ET-NRC-92-3663

Westinghouse Electric Corporation  
Nuclear and Advanced Technology Division  
P.O. Box 355  
Pittsburgh, PA 15230

AP600 RESPONSE TO NRC STAFF CONCERNS RELATED TO HIGH PRESSURE,  
FULL HEIGHT INTEGRAL TESTING

Figure 3-1: AP600 CORE MAKEUP TANK TEST SCHEMATIC

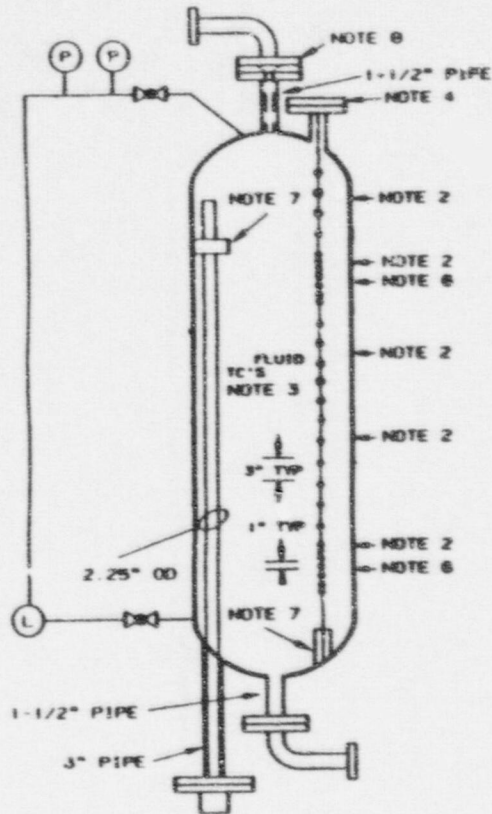
1. **Condensation in the core makeup tanks, which may cause pressure oscillations that could affect the gravity driven injection from those tanks.**

To verify this conservative design, the CMT System Test currently planned by Westinghouse will directly measure the rate of steam condensation in the CMT vs. time, vs. water level, vs. pressure, and vs. water drain flow rate. The test will be extensively instrumented to measure not only overall steam and water flow rates but also includes:

- Sets of five thermocouples installed at various depths through the CMT wall to measure the local wall heat flux (steam condensation rate). Five such local heat flux measurements are provided at different tank wall heights.

Twenty-nine thermocouples located in the CMT fluid along the length of the tank. These thermocouples are strategically placed to monitor the CMT water heatup due to steam condensation on the water surface and accumulation of condensate from the tank walls.

This test apparatus is designed to provide a greater range of steam velocities at the CMT steam inlet nozzle and a greater range of drain rates than in the plant, so that both initial and long term steam condensation conditions can be tested over a wide range. The test matrix includes tests with no water in the tank, and tests with fixed water levels so that the steam condensation on the tank walls, and on the water surface, can be separately and accurately measured.

Thus, the CMT System Test will provide an accurate simulation of the steam condensation conditions which can occur in the actual CMT. Also, this test is heavily instrumented in order to measure the steam condensation rates and observe the CMT water behavior and drain rate. Separate tests are specified in the test matrix to provide information about these phenomena and to simulate the full range of CMT operating conditions. These tests provide sufficient data to understand condensation affects on CMT performance and to verify treatment of these condensation effects in safety analysis models.

Figure 3-4: AP600 Integral Systems Test at Oregon State University

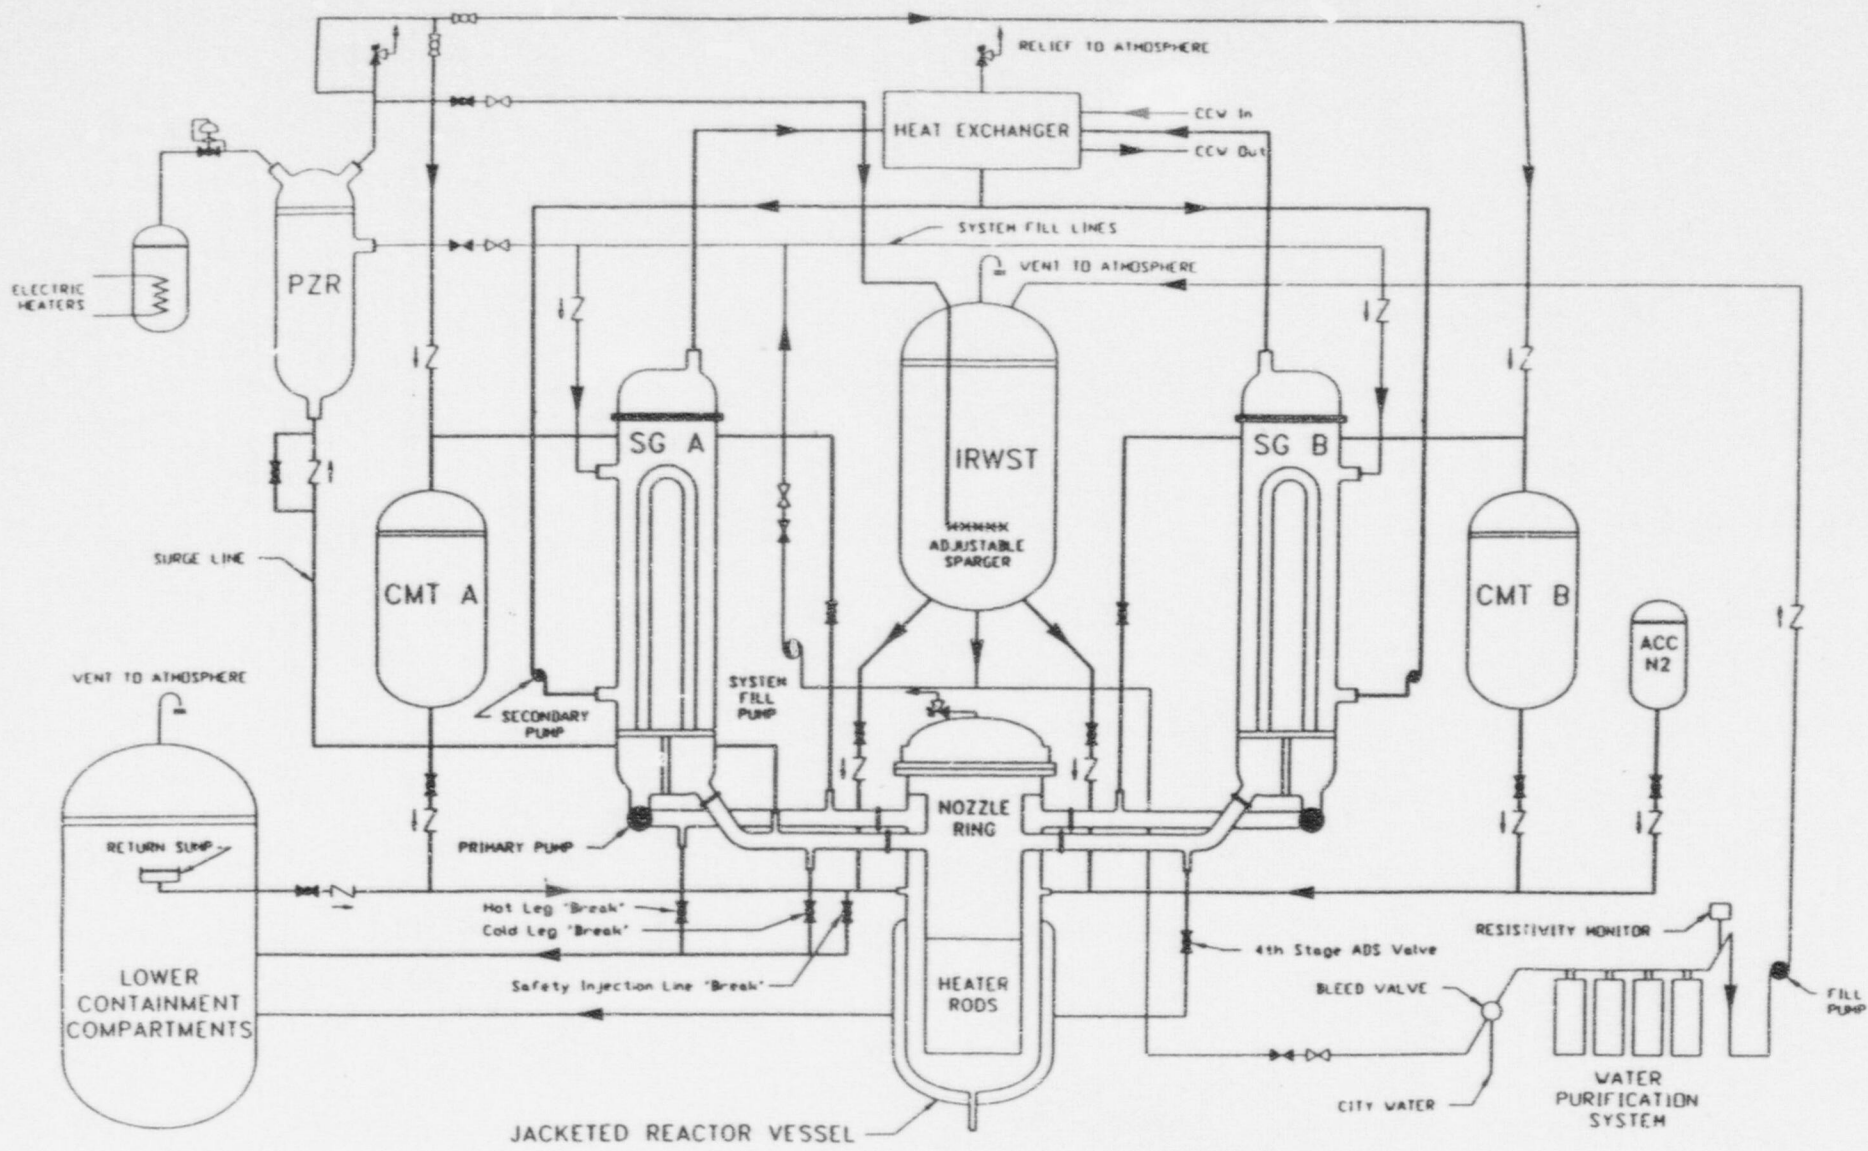
**9. Behavior of multiple natural circulation paths and possible steam generator holdup effects.**

The 1/4 scale Integral Systems Tests will also simulate the two core make-up tanks. If oscillations would occur, they will be evident and measured in the planned Integral Systems Test facility. If there is an impact of condensation on the CMT water delivery, this will be evident from the experiments. Various experiments will be performed to characterize the core make-up tank behavior. The Integral Systems Tests along with the CMT tests will be used to validate Westinghouse safety analysis models.

AP600 natural circulation behavior will be tested extensively in the planned Integral Systems Test. This facility includes all of the natural circulation paths discussed above. The 300 psi and 400°F capability of this facility is sufficient to test the natural circulation phenomena which would occur during the high pressure phase of SBLOCA. The planned CMT System test will also provide full height, high pressure data for the natural circulation behavior which drives CMT injection. These tests provide sufficient data to verify the plant analysis methods for these phenomena.
